Re: Connecticut Humane Society -- Application for Significant Regulated Activity Permit
(WET#2724)
Premises: 863-875 Danbury Road, Wilton, CT

As attorney for Connecticut Humane Society ("CHS"), this letter sets forth our responses to the comments contained in the Department of Public Works' Memorandum to the Commission dated August 5, 2021, and an email from Ms. Jennifer Zbell, Assistant Sanitarian, to Redniss & Mead ("R&M"), dated August 25, 2021. In support of the response to Comment #2 and Ms. Zbell, we enclose eight (8) copies each of the following:

EXISTING ON-SITE DRAINAGE BASIN EXHIBIT
863 DANBURY ROAD
WILTON, CT

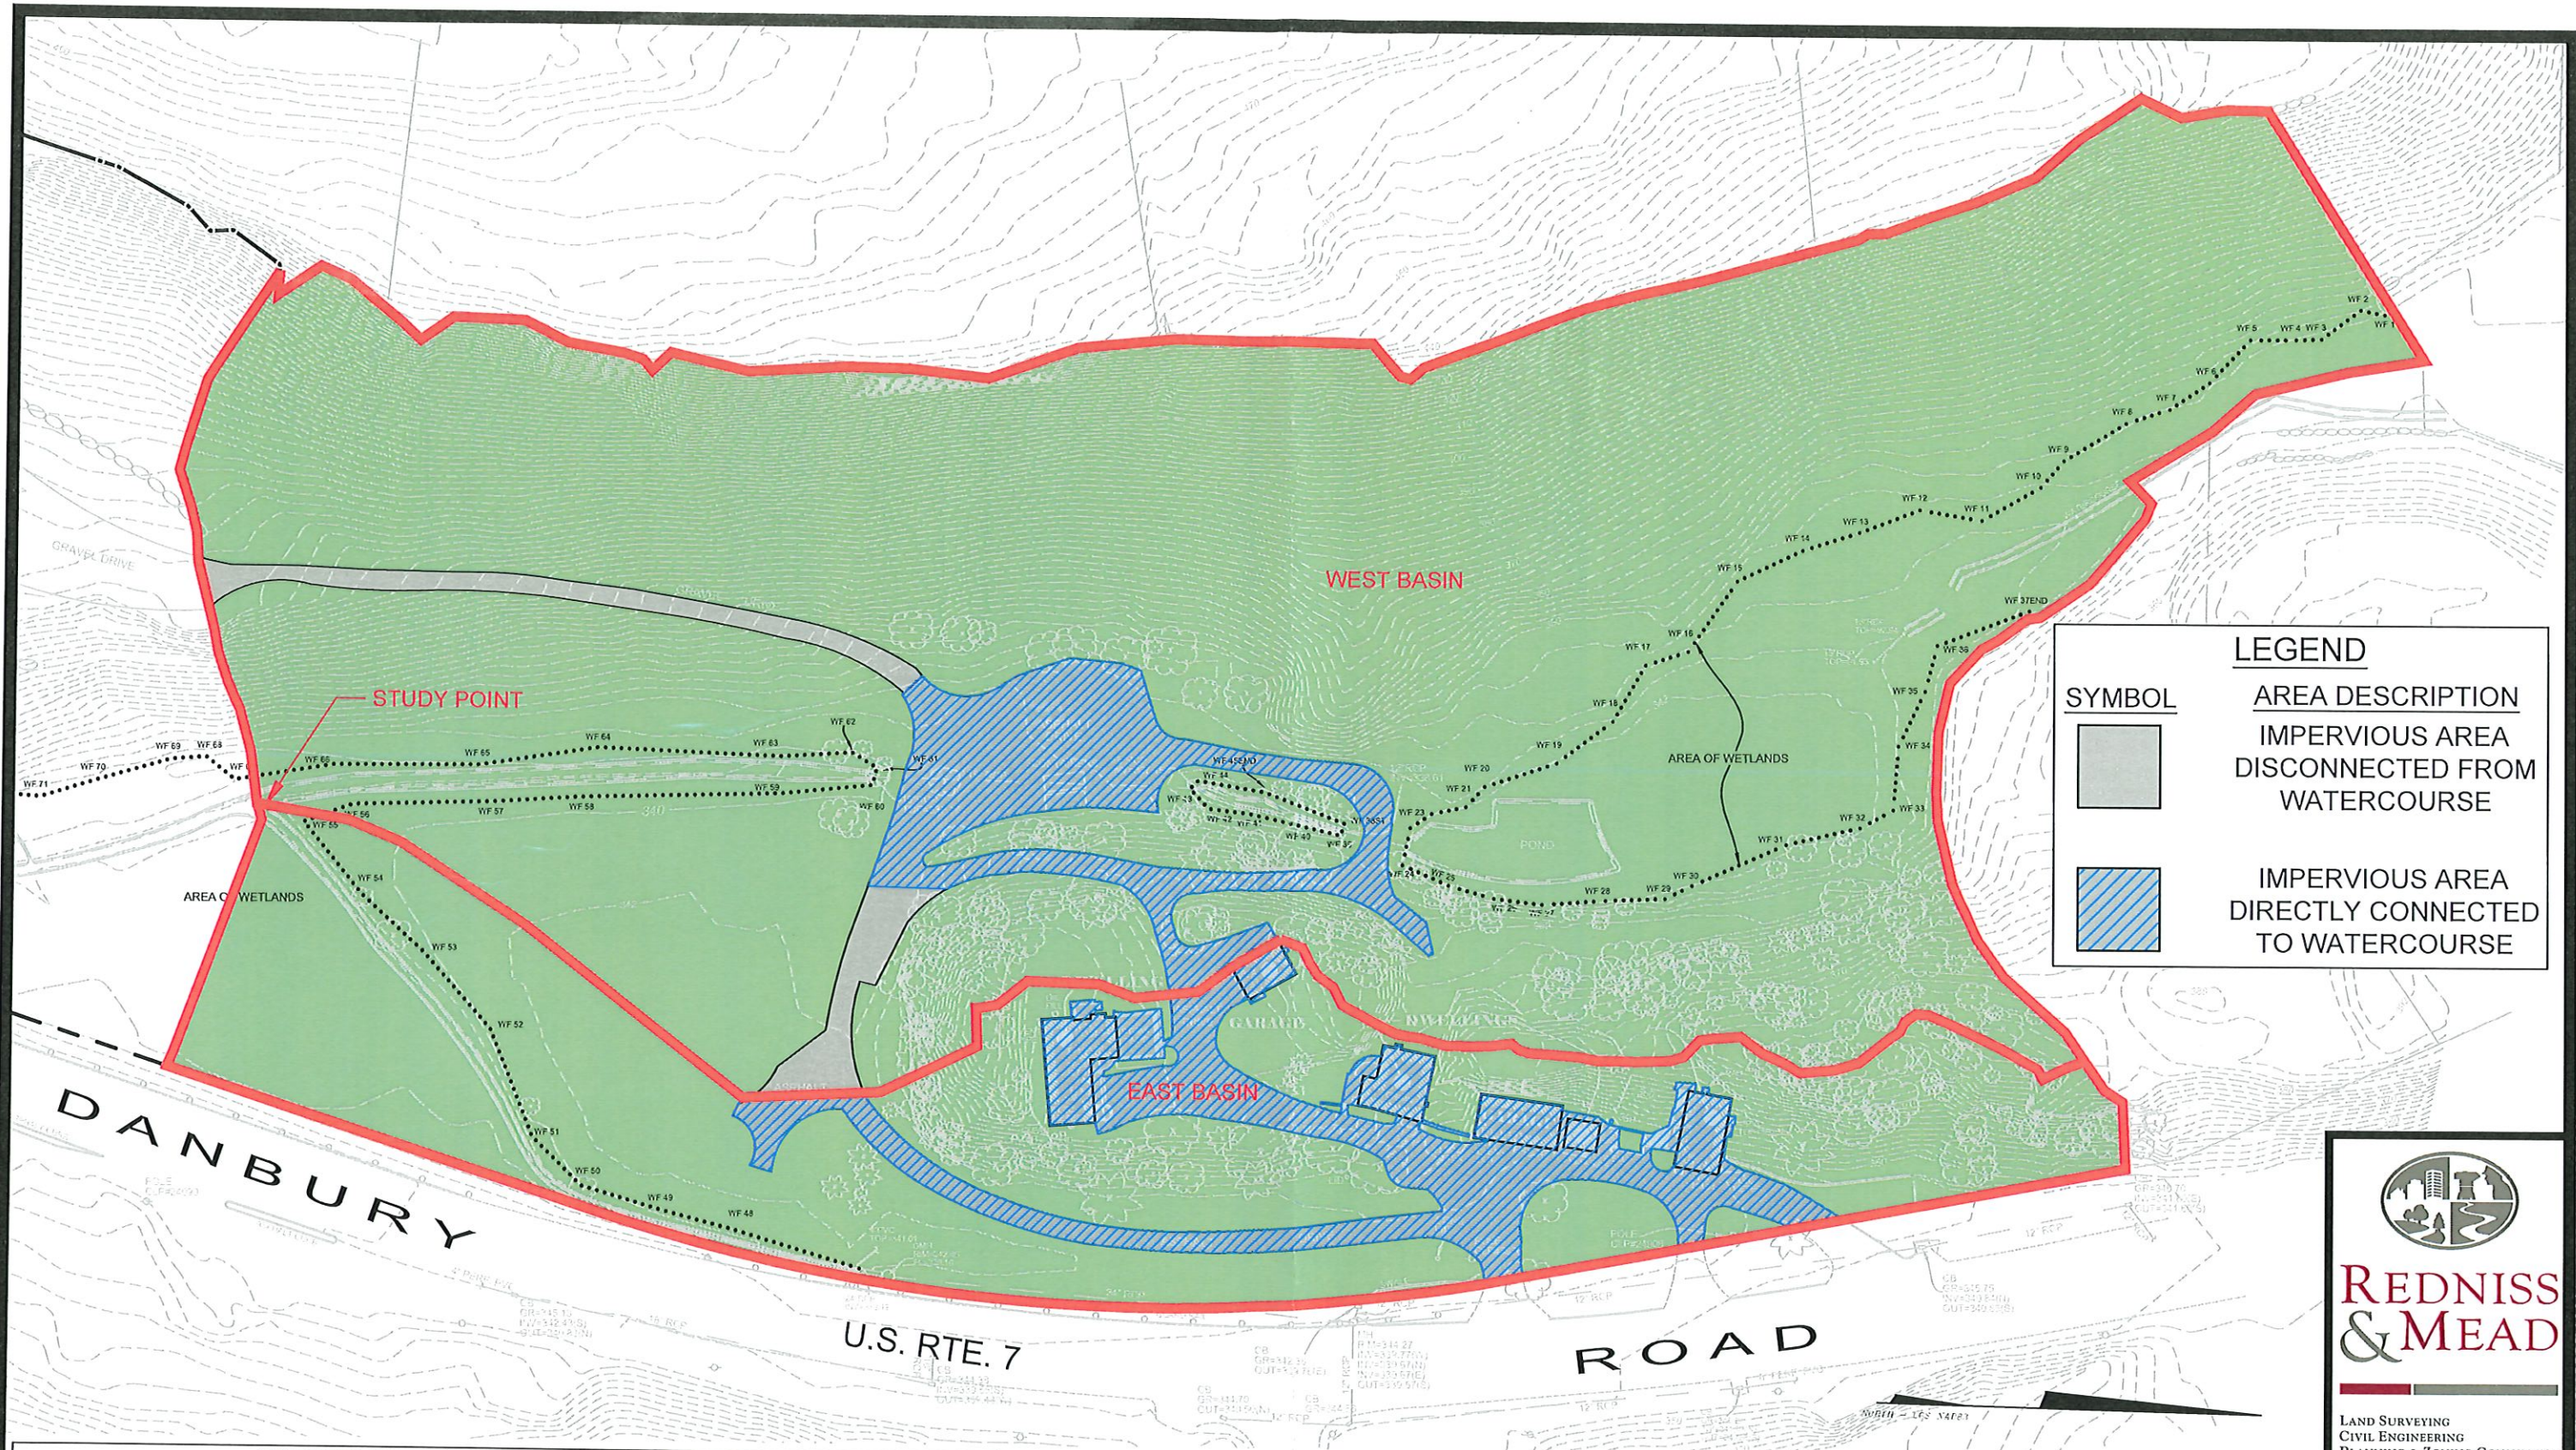
DPW Comment #2 For record tracking purposes, please provide the following:

Existing pervious surface area, existing impervious surface area directly connected to the water course, proposed pervious surface area, proposed impervious surface area disconnected from the water course, proposed impervious surface area directly connected to the water course.

Response: *CHS submits the attached Existing On-Site Drainage Basin Exhibit and Proposed On-Site Drainage Basin Exhibit prepared by R&M, dated August 16, 2021, in response to this Comment.*

SITE UTILITY PLAN
DEPICTING
863 DANBURY ROAD
WILTON, CT
PREPARED FOR
CONNECTICUT HUMANE SOCIETY

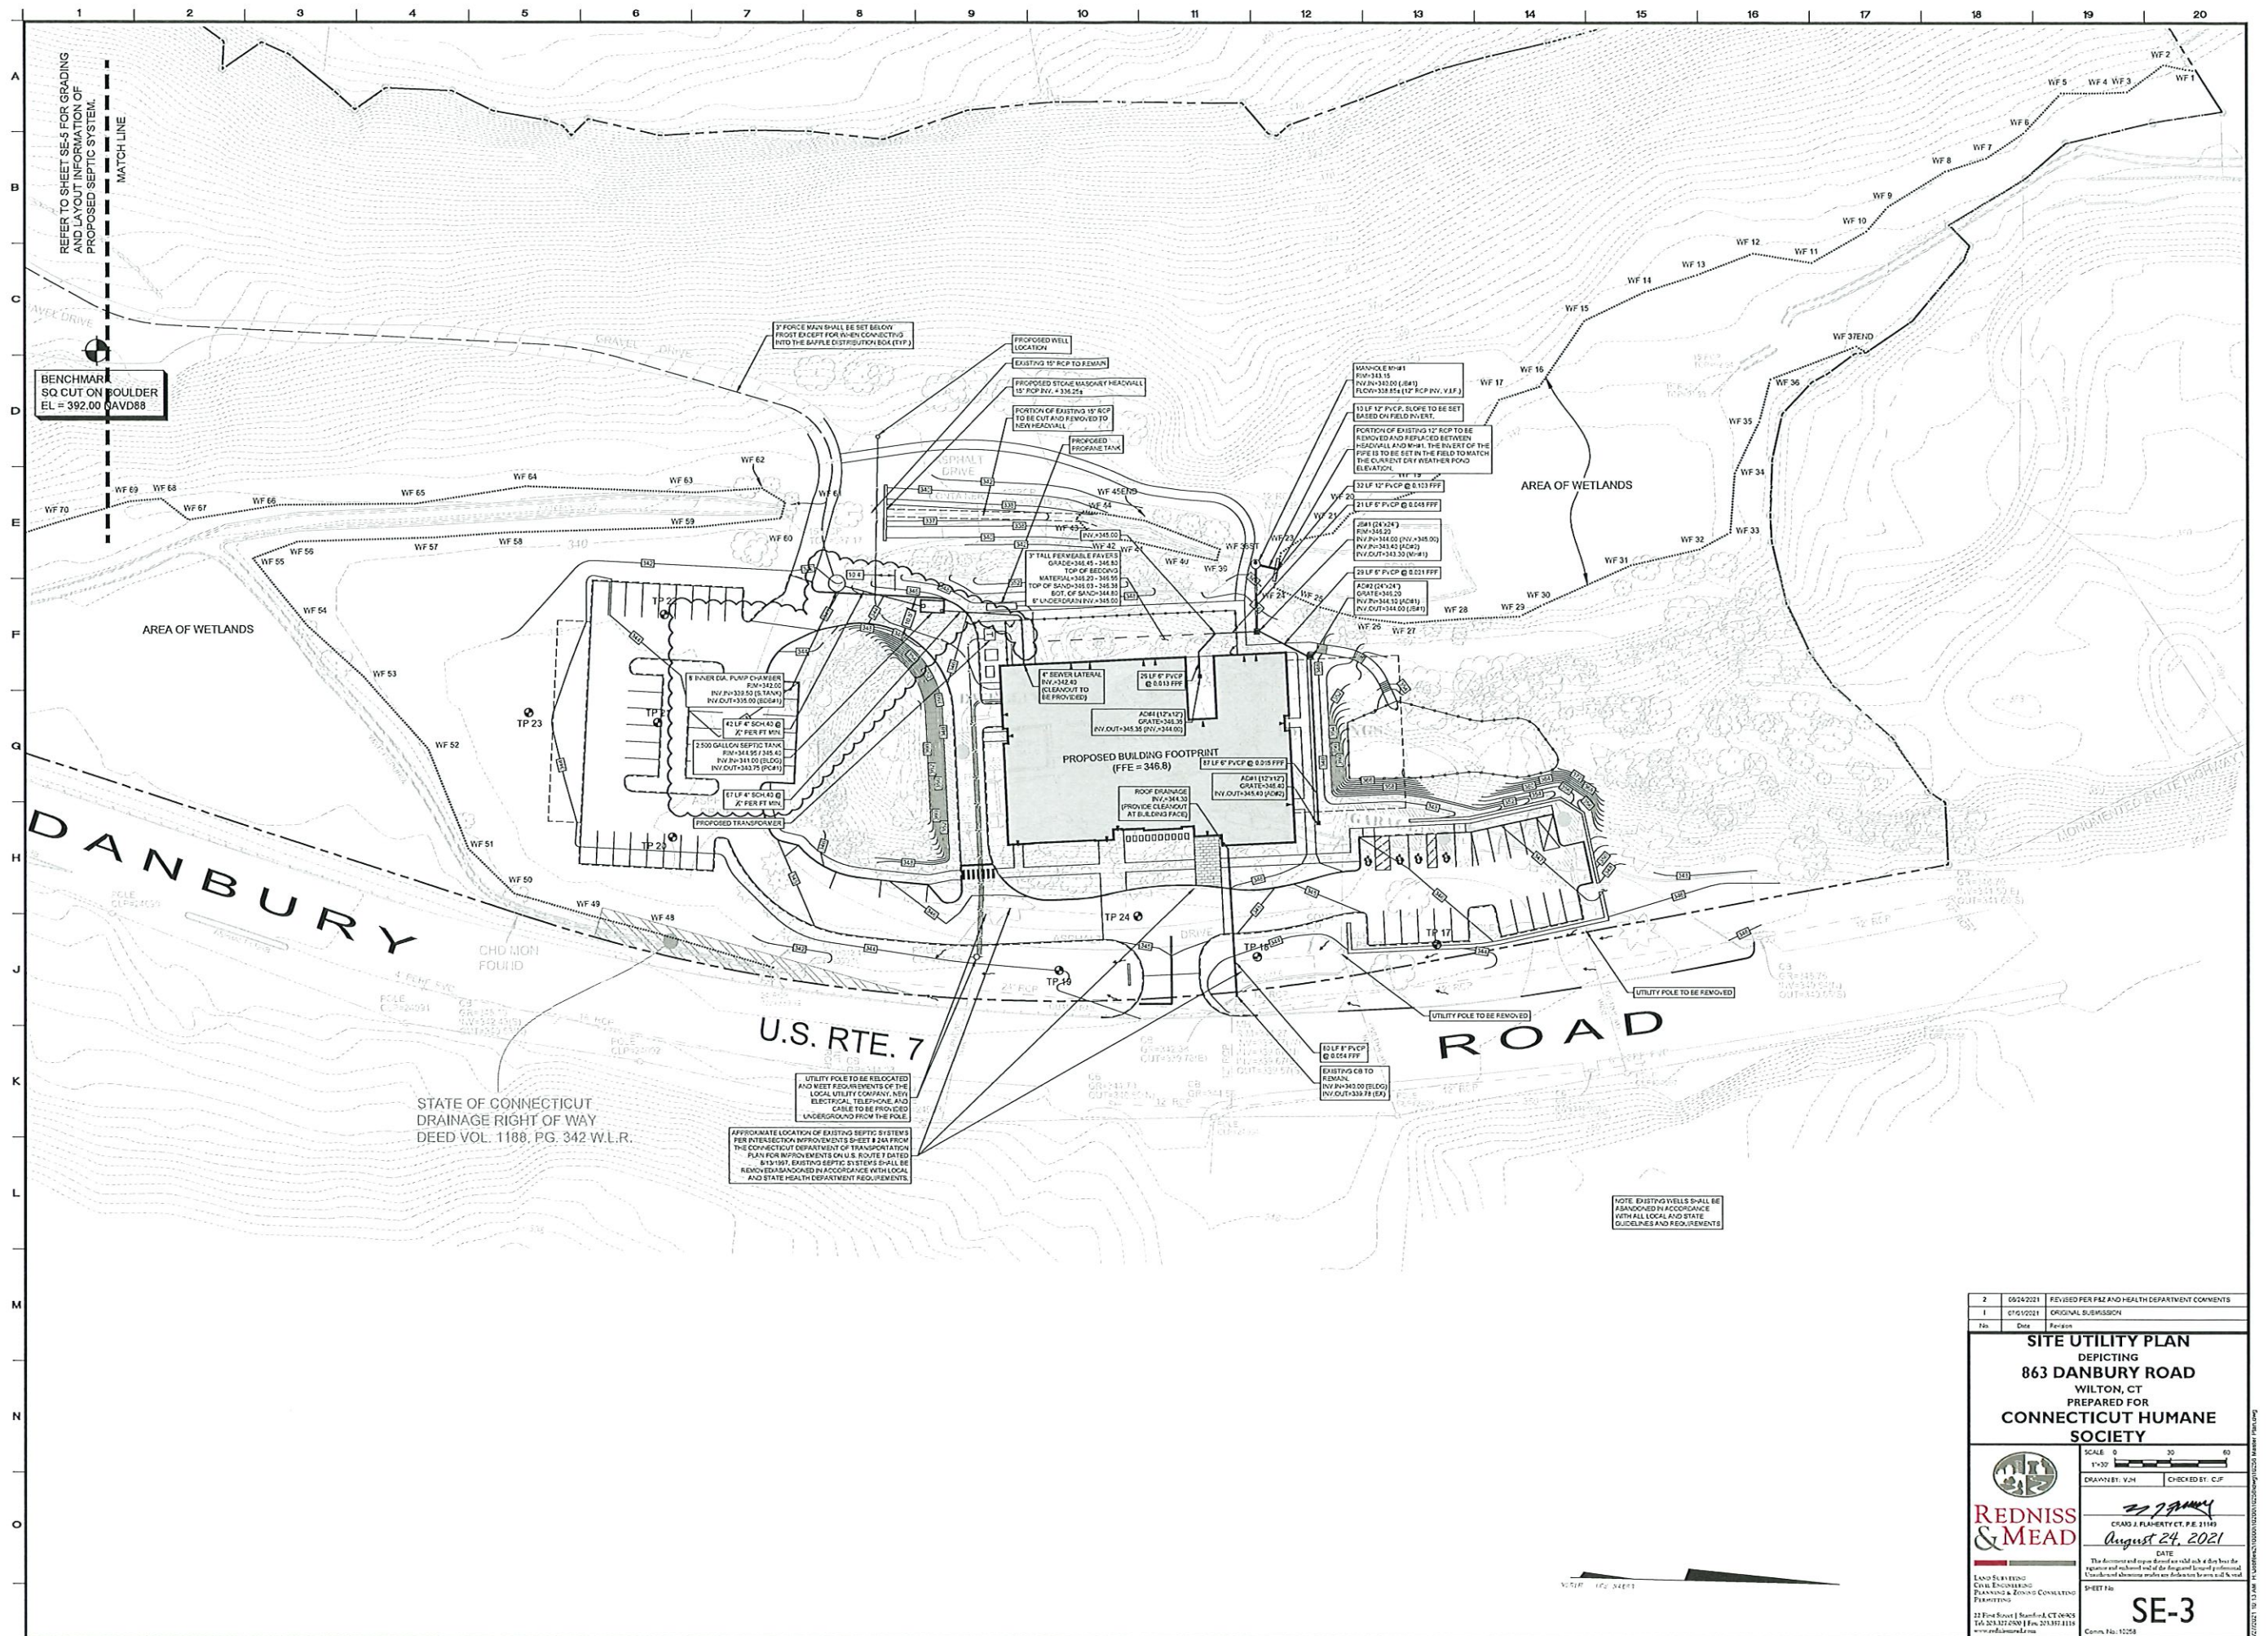
Ms. Zbell August 25, 2021 Comments: The pump chamber needs to be sized on the 24 hour storage for the gallons with the safety factor so the pump chamber needs to be at least 2200 gallons. Septic tank needs to meet 10' from water line. If we could move the septic tank from under the driveway that would be great.

Response: Redniss & Mead has made revisions to the plans as suggested by Ms. Zbell. The revised plans were very recently forwarded to Ms. Zbell for her review and are enclosed herewith. Please note that, as of this writing, we have not received an affirmative response from Ms. Zbell.
